## **DEVELOPMENT REVIEW COMMITTEE MEETING AGENDA**

DRC Meeting Draft Minutes  
Holden Avenue Planned Development  
August 10, 2021, at 11:00 am

**To:** Development Review Committee  
**From:** Brett Sollazzo, Deputy City Clerk  
**Date:** January 31, 2022  
**Re:** Haven Oaks Proposed Planned Development

Project: Haven Oaks Development Plan/Preliminary Subdivision Plan

GRADING PLAN SOUTH

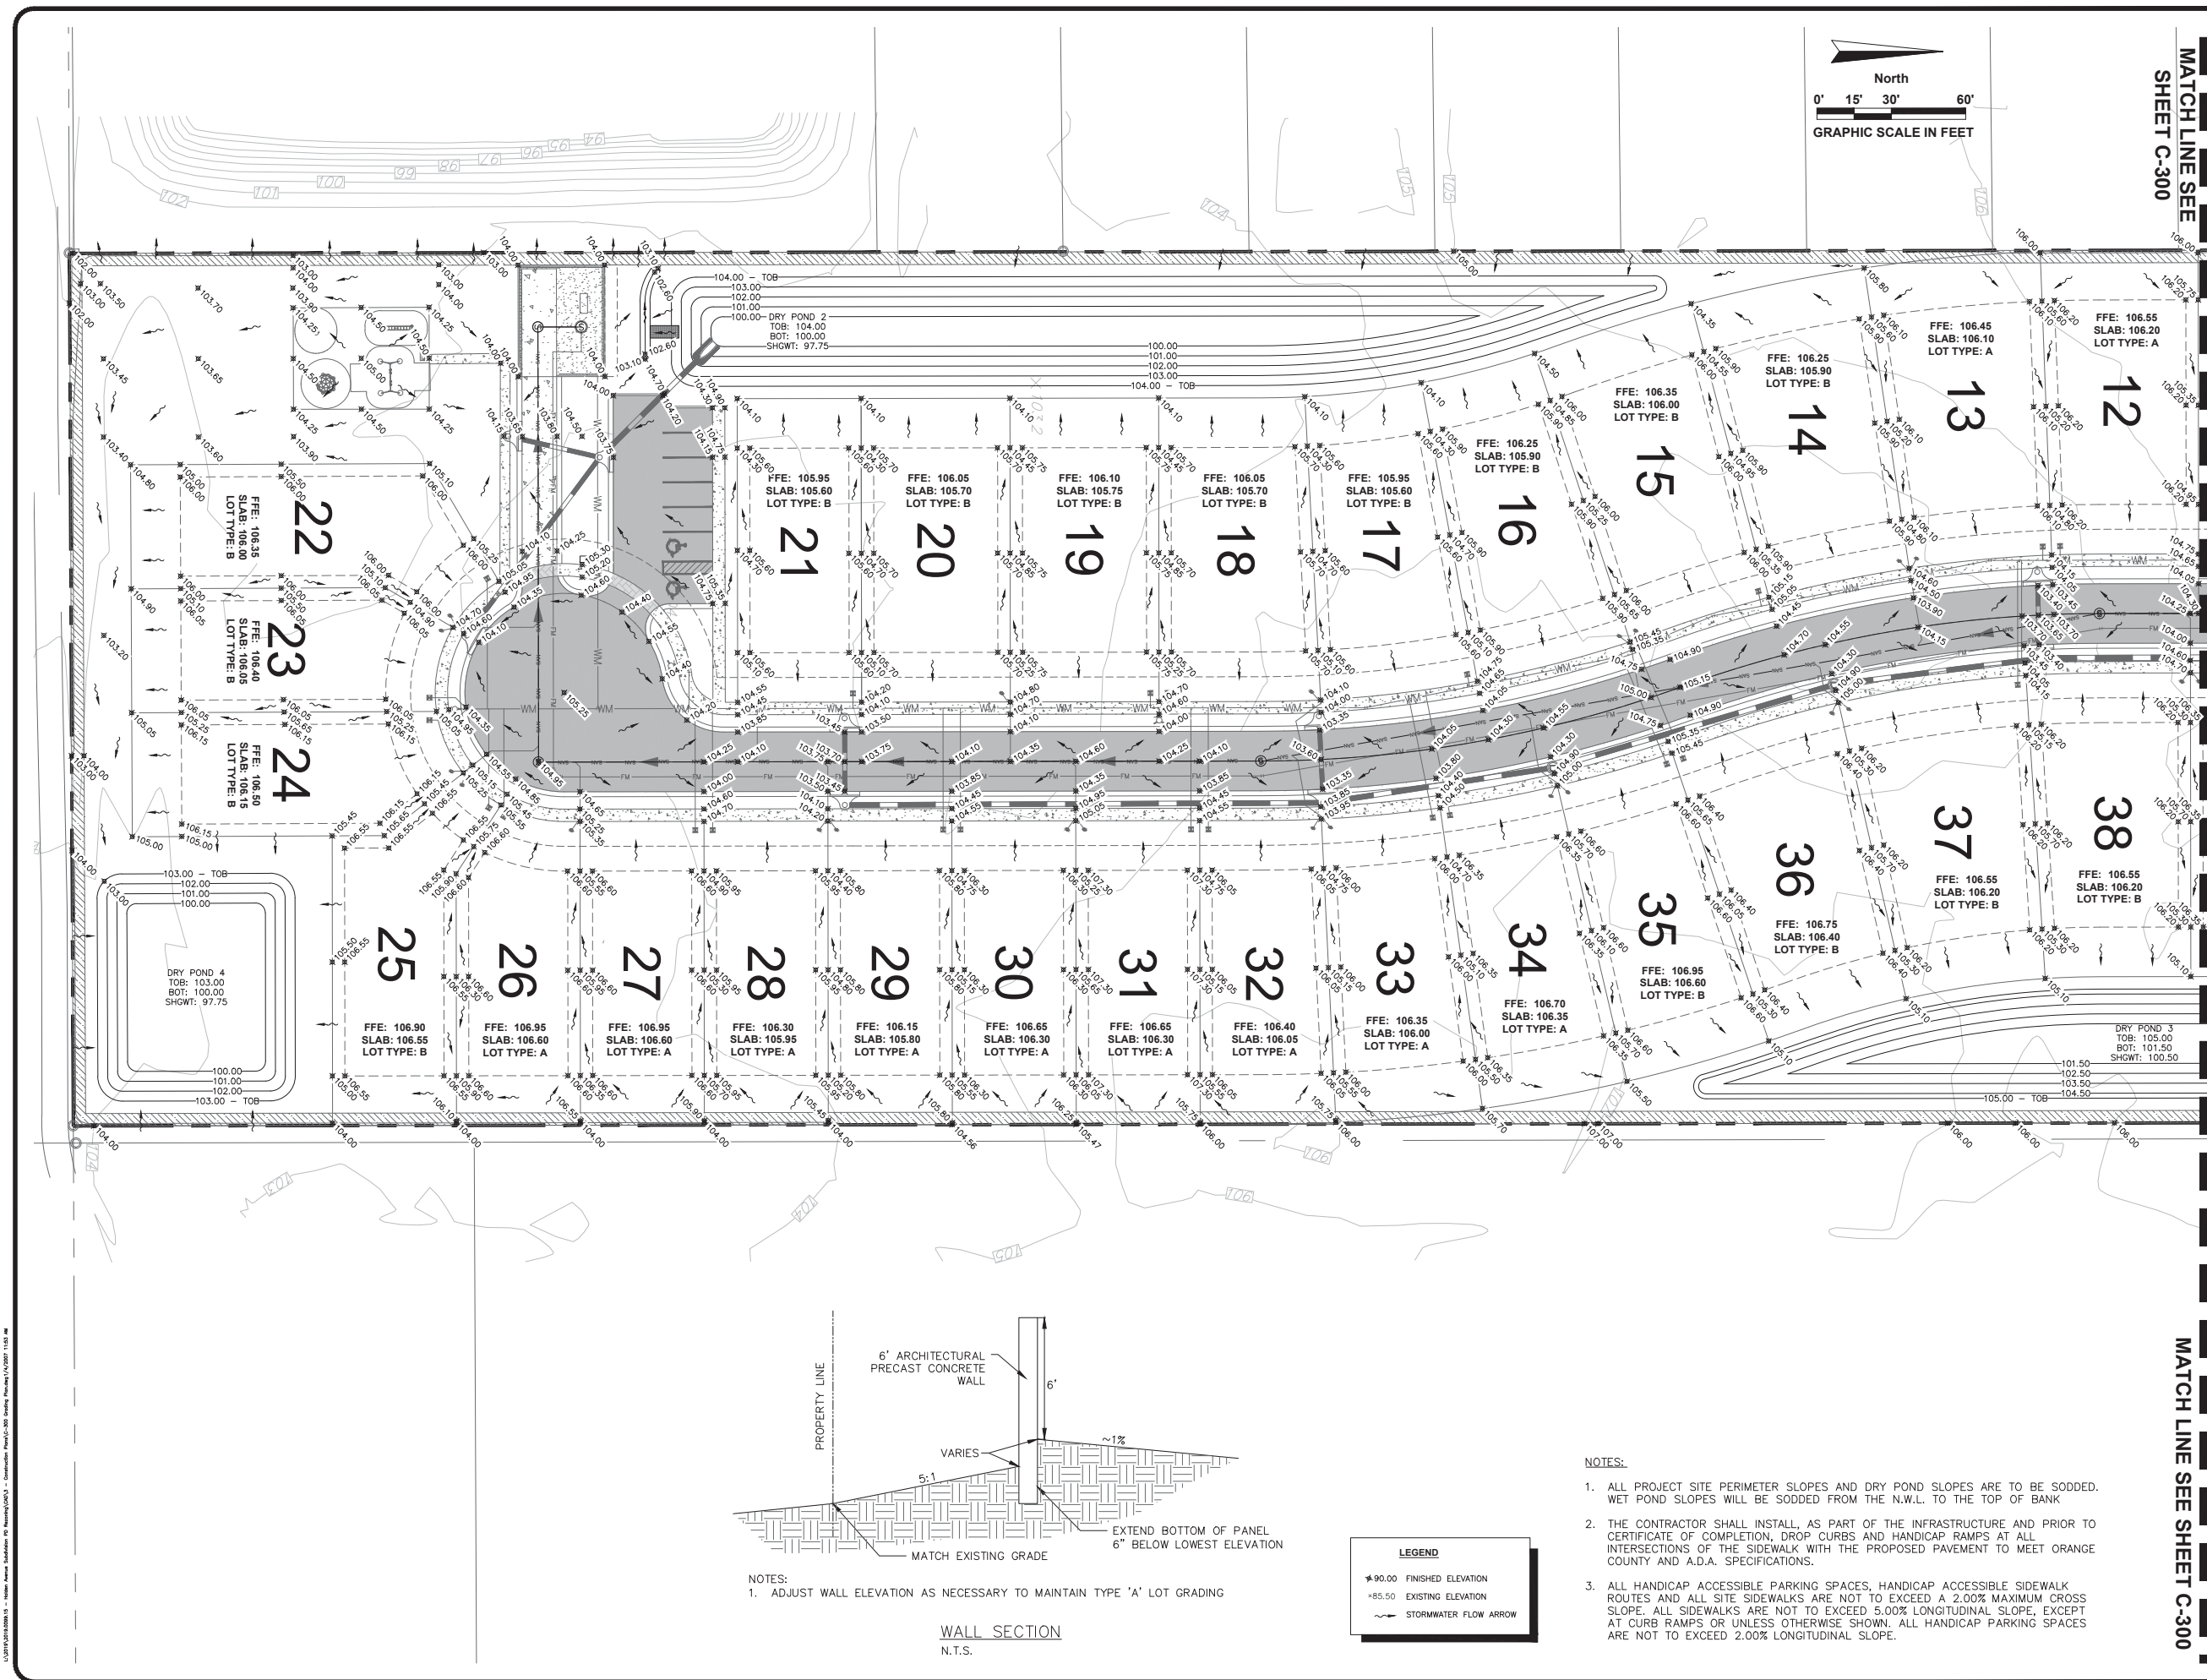
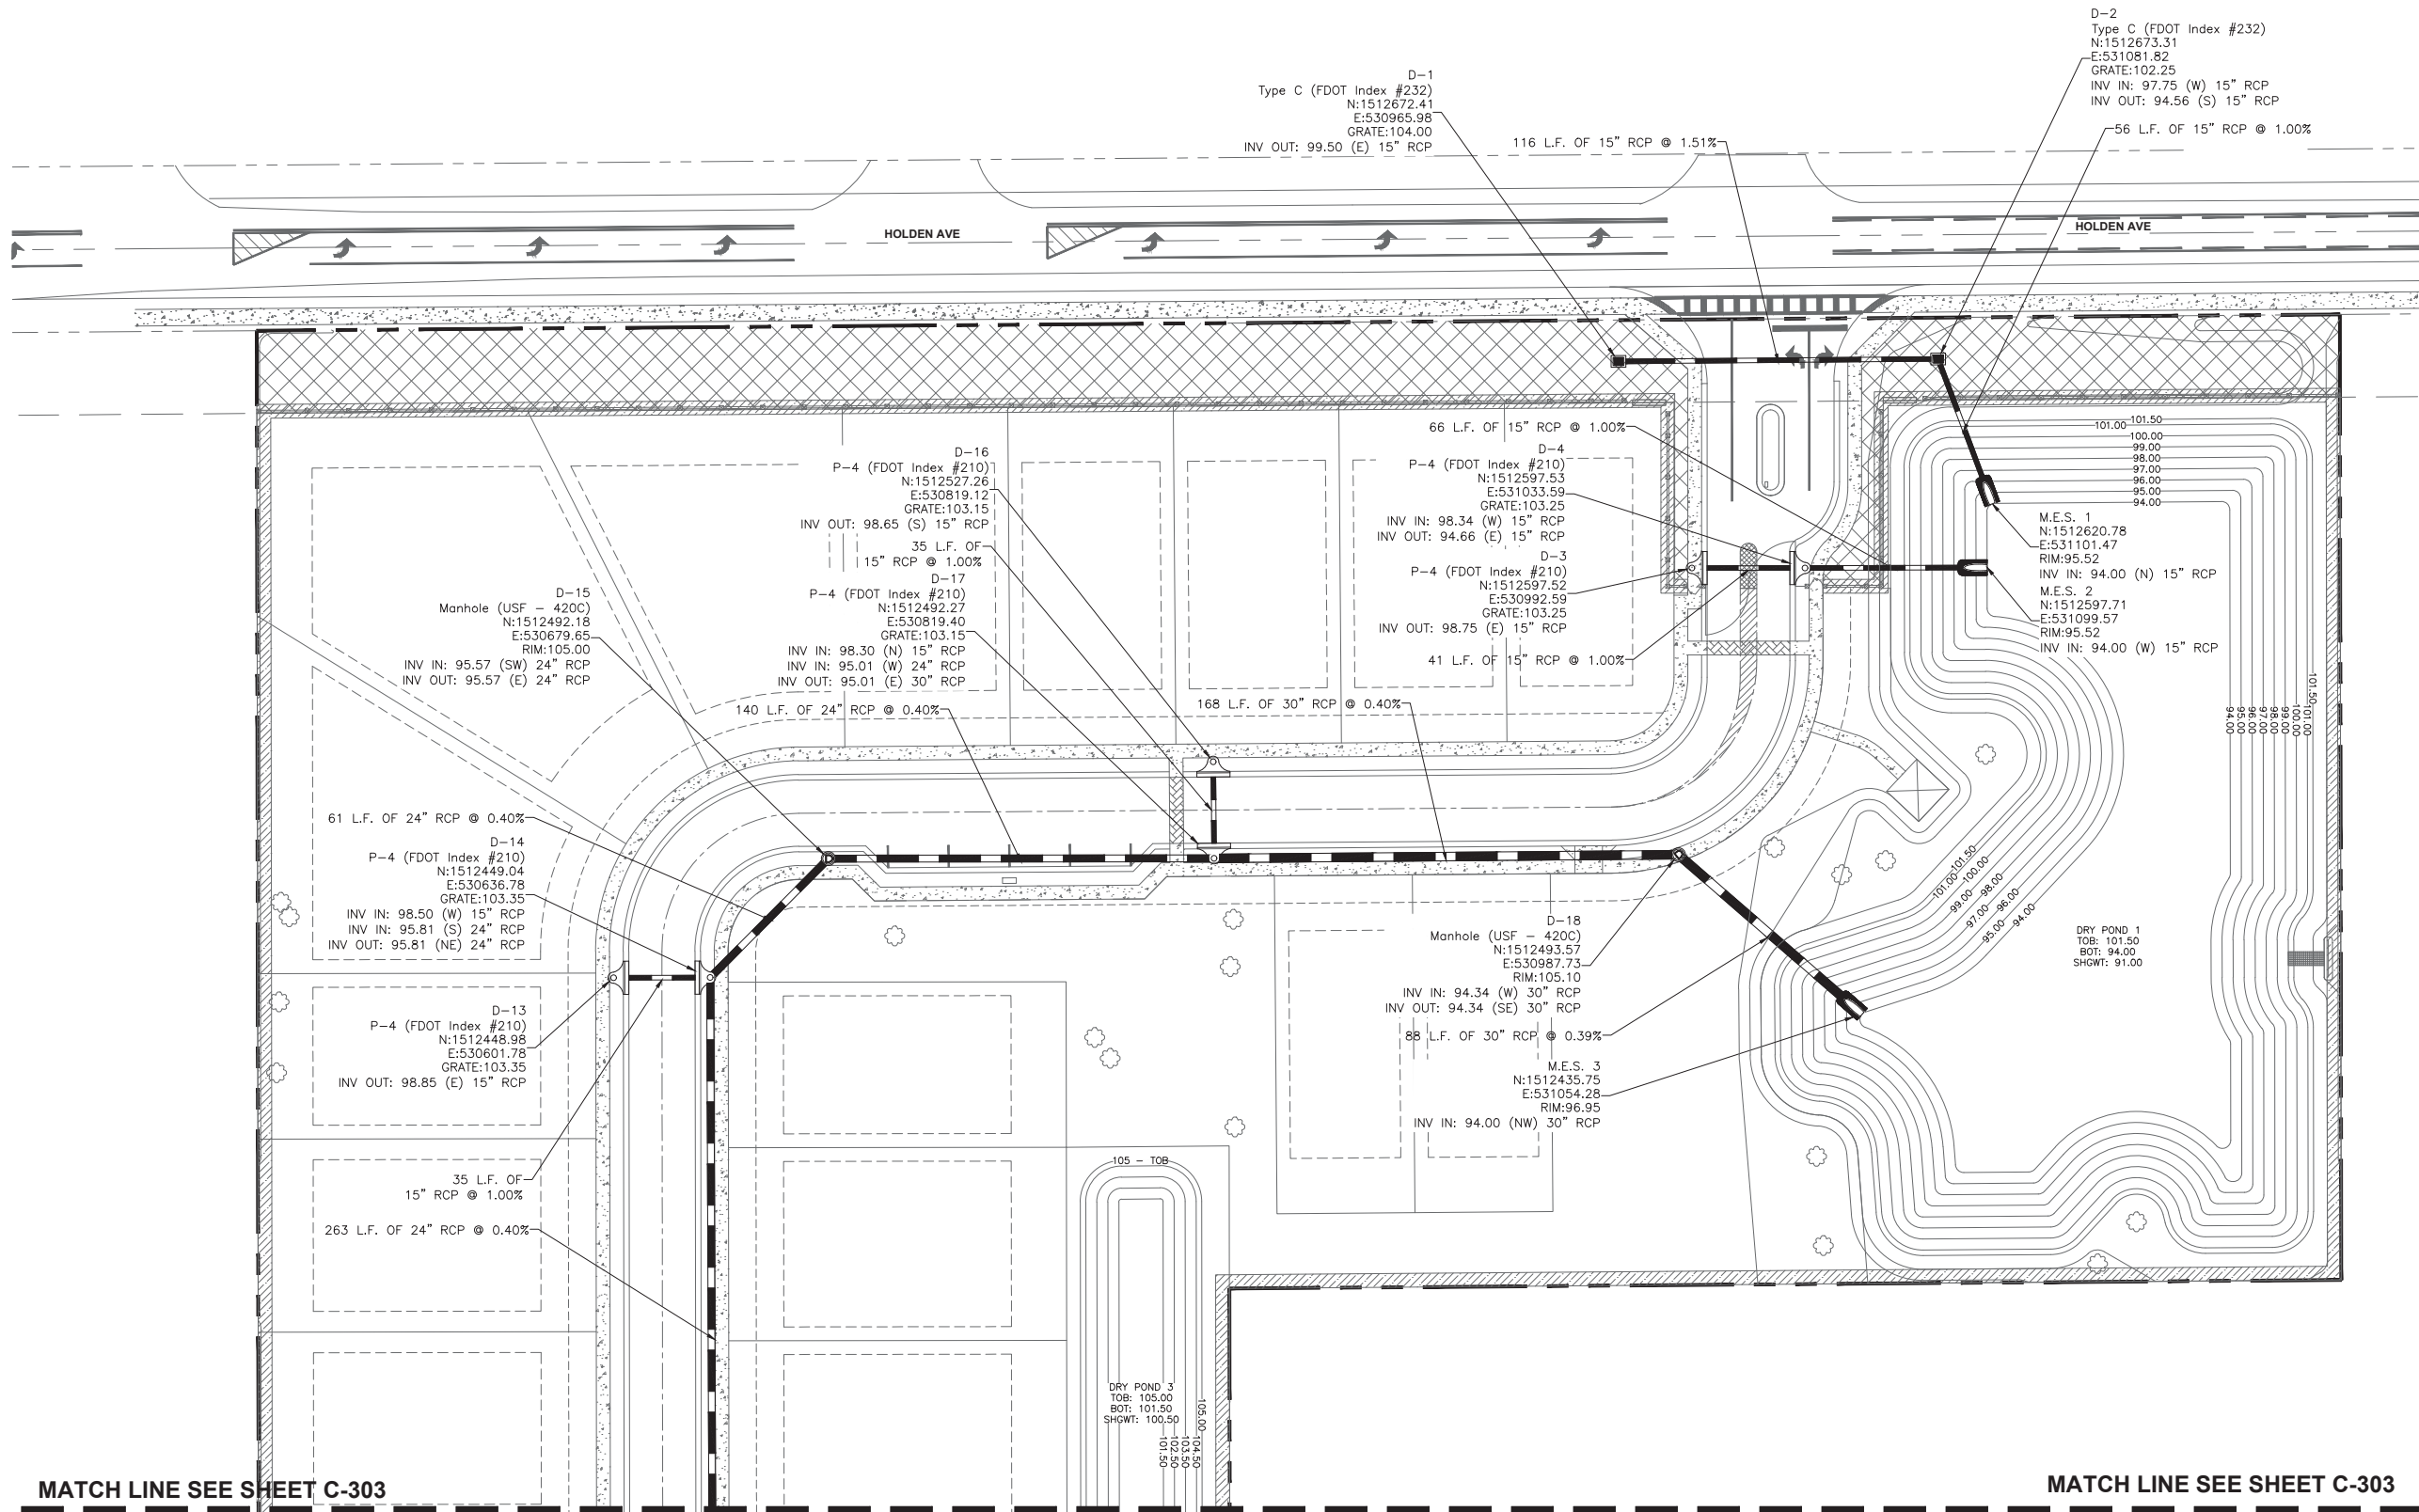
22. Sheet C-301 – insufficient spot elevations all along the south property line. In most areas, it appears the runoff from lots 22, 23, 24 and the tot lot will drain south off-site and not be

23. Sheet C-301 – Pond #2 is to have an overflow weir that ultimately discharges water off-site to the west and into the neighboring development's pond. Has this concept been approved by the adjacent development and if so why not hard pipe with an overflow box?

C-410

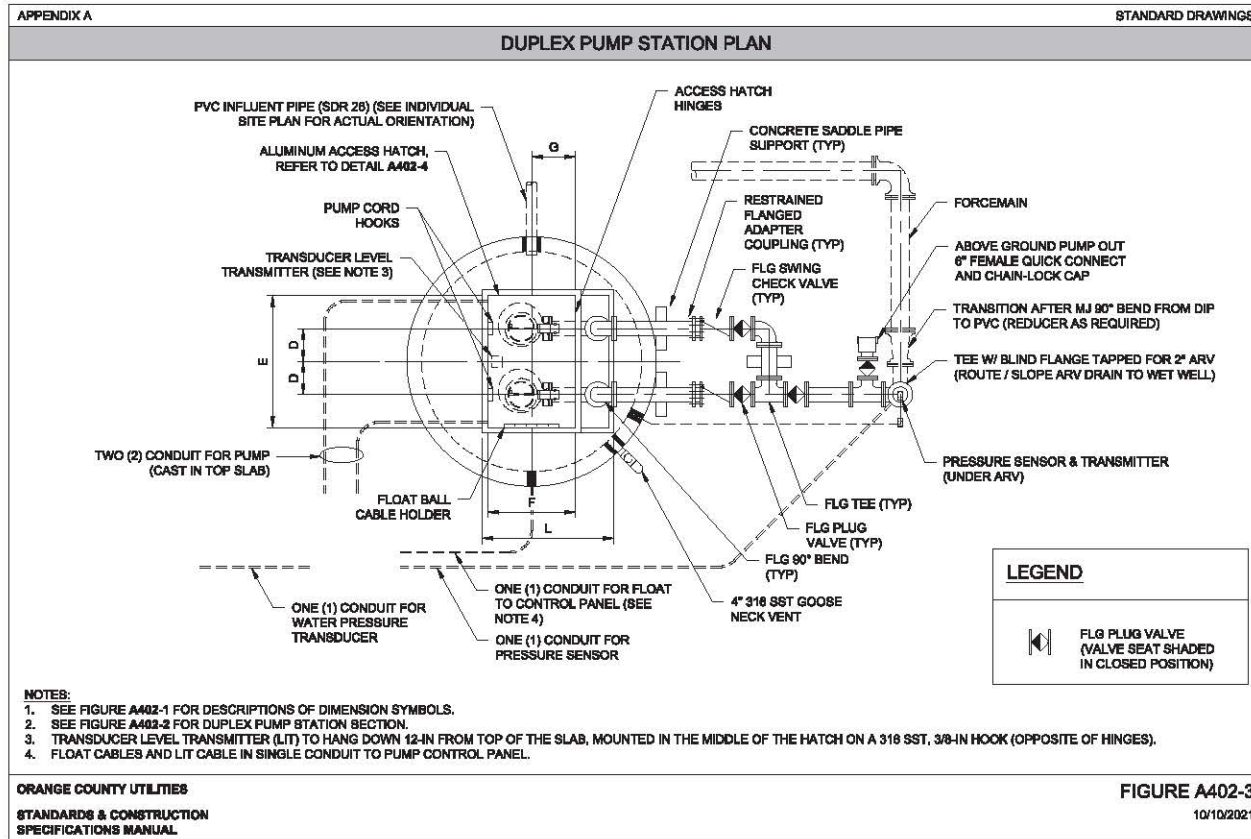
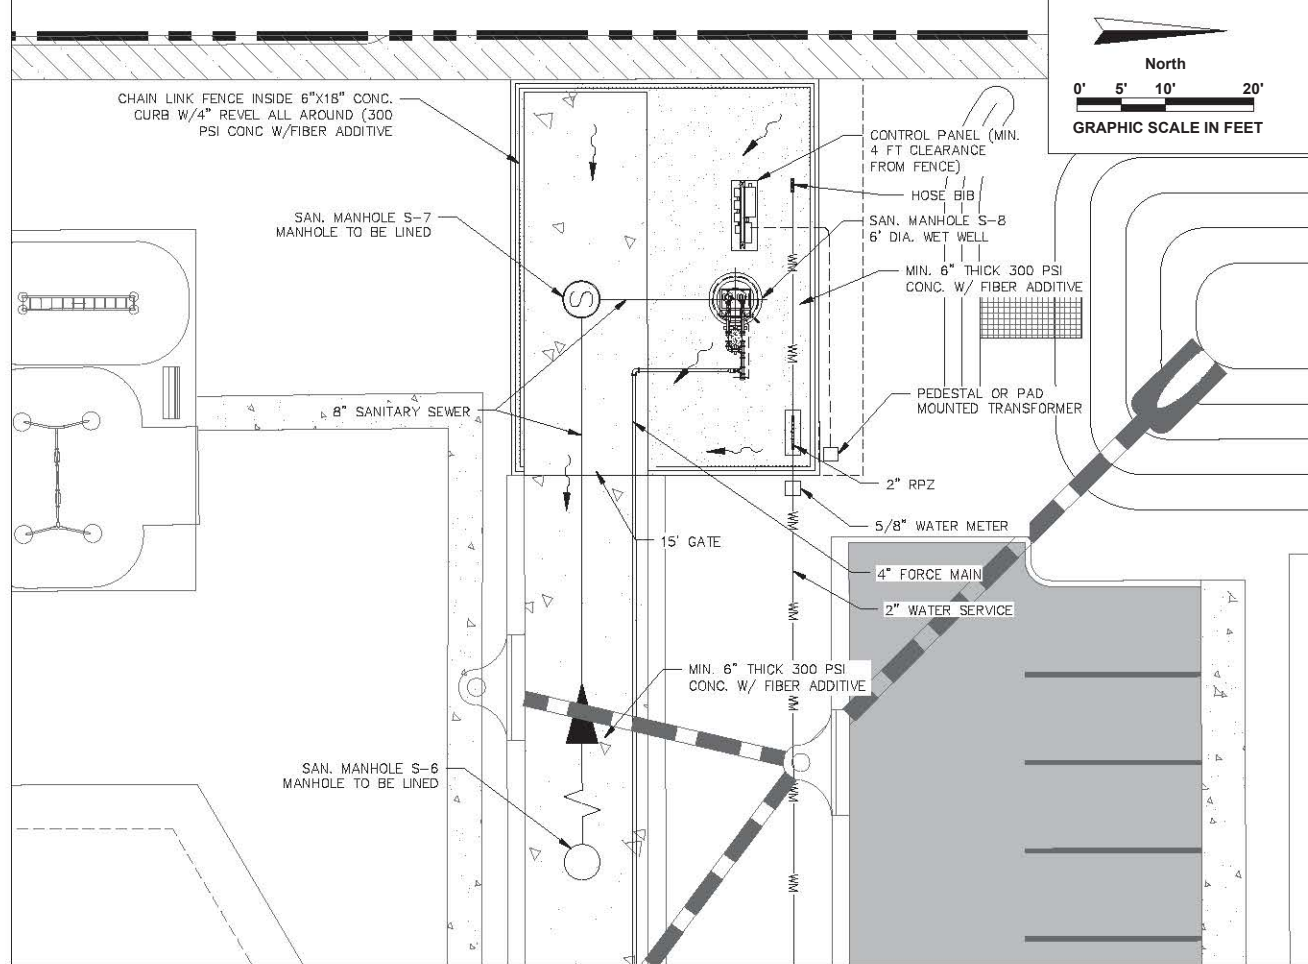
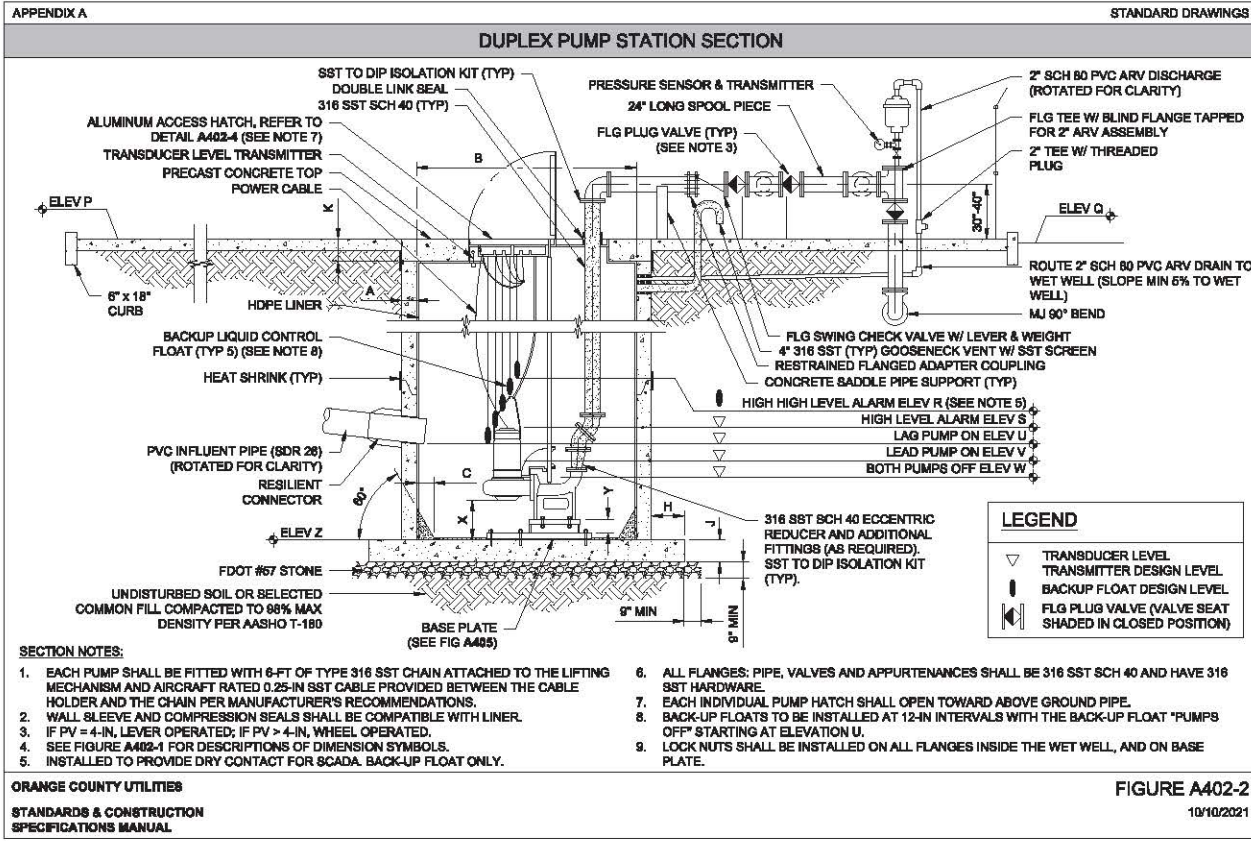
45. Sheet C-408 – details A124, A201-1, and A121-1 can be deleted as they apply to potable water and the potable water is being supplied by OUC.
46. Sheet C-410 – detail A420 can be deleted as these facilities are to be owned by OCU.
